AMENDMENT

ETS 300 019-1-3
A1

This amendment A1 modifies
the European Telecommunication Standard ETS 300 019-1-3 (1992)

Equipment Engineering (EE); Environmental conditions and environmental tests for telecommunications equipment; Part 1-3: Classification of environmental conditions Stationary use at weatherprotected locations

Figure 7: Earthquake Response Spectrum

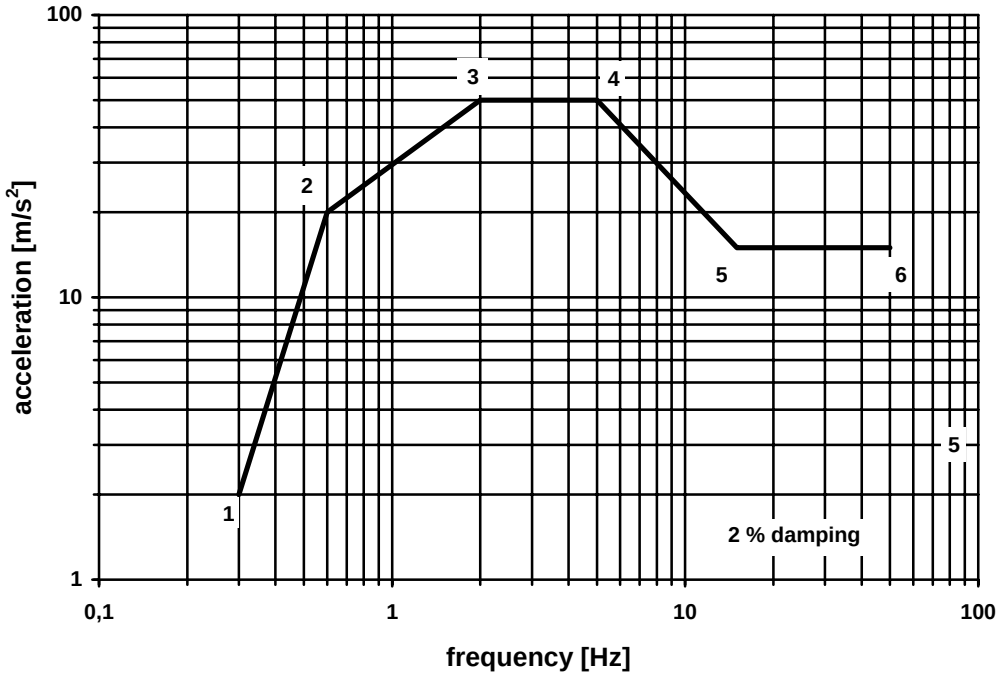
After the end of subclause 5.5, add a new subclause:

5.6 Earthquake conditions

The parameter severities that shall be used for classes 3.1 to 3.5 are shown in table 6.

The corresponding Response Spectrum, assuming a damping ratio of the single degree-of-freedom oscillators N = 2 %, is described in figure 7 and table 7.
